**PLANNED UNIT DEVELOPMENT  
& SUBDIVISION STAFF REPORT****Date: November 1, 2007****DEVELOPMENT NAME**

McMurray Place Subdivision

APPLICATION NUMBER 24 & 25 DATE November 1, 2007

# SITE PLAN

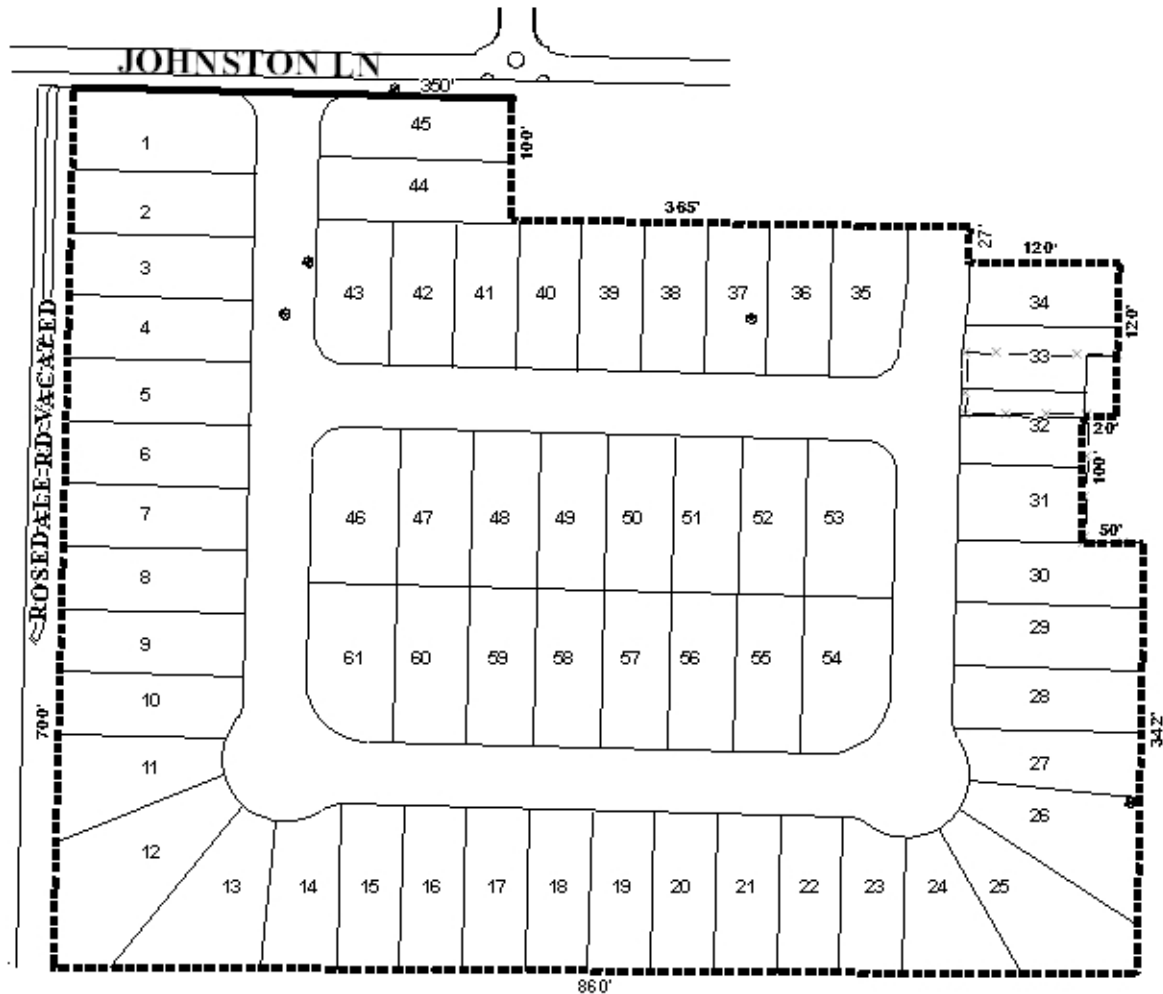
The site fronts onto Johnston Lane, a minor street that does not appear to meet the minimum right-of-way width of 50 feet, as required in Section V.B.14. of the Subdivision Regulations (the plat does not indicate the right-of-way width of Johnston Lane, as required by the Subdivision Regulations). The plat should be revised to dedicate right-of-way sufficient to provide 25-feet of right-of-way, as measured from the centerline of Johnston Lane, or the plat should be revised to show the right-of-way width if the existing width is adequate. Hillcrest Road, a major street, is located approximately 250 feet West of the site.

As an R-3 zoned site, the maximum allowed site coverage by right is 45%, thus the proposed PUD request for 45% is technically unnecessary. However, both the PUD site plan and the Subdivision plat should have a note stating that the maximum building site coverage is 45% in order to facilitate future residential building site plan reviews.

Regarding the proposed building setbacks, 25-feet is proposed for the front yard setback, while 20-feet is proposed as the street-side side yard setback for corner lots. Other side yard setbacks are proposed to be zero feet and 10-feet. The rear yard minimum setback would remain 8-feet. The PUD site plan depicts a 25-foot setback from all streets (except from Johnston Lane), while the Subdivision plat provides a note stating 25-foot setbacks, but does not depict any setbacks. Both the PUD site plan and Subdivision plat should be revised to depict, label and note the requested setbacks, especially regarding where the 20-foot side yard setback for corner lots is desired, and which side of each lot will be required to provide a minimum 10-foot side yard setback (with the other side yard setback being 0 feet). As a 20-foot side yard setback for corner lots is allowed by the Zoning Ordinance, but not by the Subdivision Regulations, the Subdivision Regulation requirements should be waived in favor of the requested setbacks. The corner lot side-yard setback should also be depicted from Johnston Lane.

Thirty-seven of the proposed sixty-one lots will be less than 7,200 square feet, thus a waiver of Section V.D.2. of the Subdivision Regulations will be required. Due to the reduced size of many of the lots, each lot should be limited to one curb-cut, with the size, design and location to be approved by Traffic Engineering and conform to AASHTO standards.

As storm water detention will likely be required for the development, and as no information has been provided by the applicant regarding how storm water will be handled (detention pond versus in pipe storage), this application should be heldover to allow the applicant to address the storm water issues, and to revise the PUD site plan and Subdivision plat to depict setbacks. As a reminder, PUD approval is site plan specific, thus if a detention pond will be provided, the general location must be depicted and appropriately labeled (storm water detention common area) on the site plan and plat.

Finally, the site plan and plat depict an area of land behind proposed lots 32 and 33 that is not labeled as a lot or any other use. Aerial photographs from 2006 imply that the house fronting onto Schuab Avenue is using this area as well as the rest of area to the McCay Avenue right-of-way. If the depicted block of land is being sold to the adjacent single-family residence, then the residence should be included within the Subdivision application so that a new lot can be created.

- 1) Dedication of right-of-way sufficient to provide 25-feet of right-of-way, as measured from the centerline of Johnston Lane, or revision the plat to show the right-of-way width if the existing width is adequate (already 50 feet);

- 2) Placement of a note on the plat stating that a 6-foot high privacy fence or masonry wall shall be provided, with appropriate permits, as a buffer around the perimeter of the development, except within any required setback area adjacent to a street;

- 3) Placement of a note on the plat stating that the building site coverage is limited to 45%;
- 4) Depiction, labeling and notation of the requested setbacks, including from Johnston Lane (25-foot front, 20-foot street-side side yard, 10-foot non-street side yard, 0-foot other side yard, 8-foot rear), with clear indication of which side will be the zero lot line;

- 5) Placement of a note on the plat stating that each lot is limited to one curb-cut, with the size, design and location to be approved by Traffic Engineering, and to conform to AASHTO standards;

- 6) Revision of the plat to depict and label any required storm water detention basin common area (*minimum detention for a 100-year storm with a 10 year release rate*), with accompanying drainage and utility easements, or provision of a statement if storm water will be accommodated by other means (such as in pipe storage);

- 7) Revision of the plat to eliminate the unexplained lot behind lots 32 and 33, or revision of the application (with new labels and postage for notification) to include the adjacent single-family residence so that a new lot can be created; and

- 8) Revision of lot size labels as necessary due to other revisions to the plat.

- 2) Dedication of right-of-way sufficient to provide 25-feet of right-of-way, as measured from the centerline of Johnston Lane, or revision the site plan to show the right-of-way width if the existing width is adequate (already 50 feet);

- 3) Placement of a note on the site plan stating that a 6-foot high privacy fence or masonry wall shall be provided, with appropriate permits, as a buffer around the perimeter of the development, except within any required setback area adjacent to a street;

- 4) Placement of a note on the site plan stating that the building site coverage is limited to 45%;
- 5) Depiction, labeling and notation of the requested setbacks, including from Johnston Lane (25-foot front, 20-foot street-side side yard, 10-foot non-street side yard, 0-foot other side yard, 8-foot rear), with clear indication of which side will be the zero lot line;

- 6) Placement of a note on the site plan stating that each lot is limited to one curb-cut, with the size, design and location to be approved by Traffic Engineering, and to conform to AASHTO standards;
- 7) Revision of the plat to depict and label any required storm water detention basin common area (*minimum detention for a 100-year storm with a 10 year release rate*), with accompanying drainage and utility easements, or provision of a statement if storm water will be accommodated by other means (such as in pipe storage);
- 8) Revision of the site plan to eliminate the unexplained lot behind lots 32 and 33, or revision of the application (with new labels and postage for notification) to include the adjacent single-family residence so that a new lot can be created; and
- 9) Revision of lot size labels as necessary due to other revisions to the site plan.
